Access Compliance Report Public Rights-of-Way (Curb Ramps)

Main Street: STANTON Cross Street: STANTON Location: NE

ADA ID: RPRK220126114243 Ramp Type: Type 4 - Parallel Initial Pass/Fail: Fail Overall Compliance: No Severity Score: 30

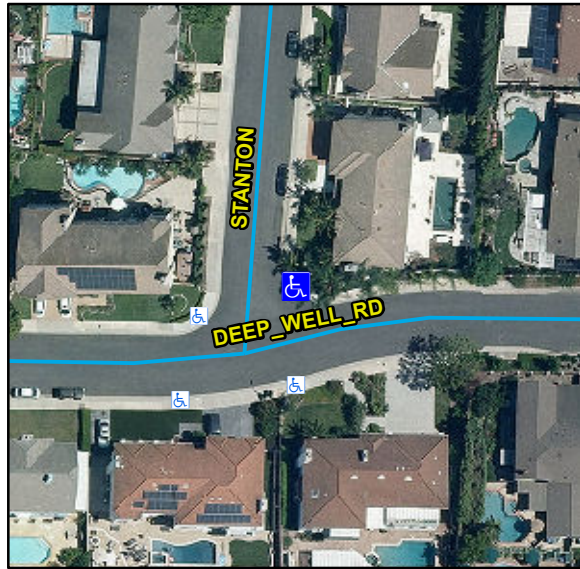
Compliance	Description	Data	Compliance	Description	Data
N/A	Ramp Length LT (in)	89	N/A	Ramp Length RT (in)	111
Yes	Ramp Width LT (in)	55	Yes	Ramp Width RT (in)	55
Yes	Ramp Run Slope LT (%)	2.8	No	Ramp Run Slope RT (%)	13.3
Yes	Ramp Cross Slope LT (%)	0.2	Yes	Ramp Cross Slope RT (%)	1.4
N/A	Landing Present	N/A	N/A	DWS Provided	N/A
N/A	Landing Length (in)	N/A	N/A	DWS Contrast	N/A
N/A	Landing Width (in)	N/A	N/A	DWS Length (in)	N/A
N/A	Landing Run Slope (%)	N/A	N/A	DWS Full Width	N/A
N/A	Landing Cross Slope (%)	N/A		DWS Offset Type	N/A
N/A	Landing Movement Obstructed?	N/A	N/A	DWS Offset Left (in)	N/A
	Landing Movement Type	N/A	N/A	DWS Offset Right (in)	N/A
N/A	Landing Shared	N/A			
N/A	Clear Space	Yes			
N/A	Clear Space To Crosswalk (in)	N/A			
N/A	Marked Crosswalk 1	No	N/A	Marked Crosswalk 2	No
	Crossing 1 Direction	W		Crossing 2 Direction	S
	Marked Crosswalk 1 Width (in)	N/A		Marked Crosswalk 2 Width (in)	N/A

Remove & Replace Curb Ramp With Two New Directional Ramps or Equivalent.
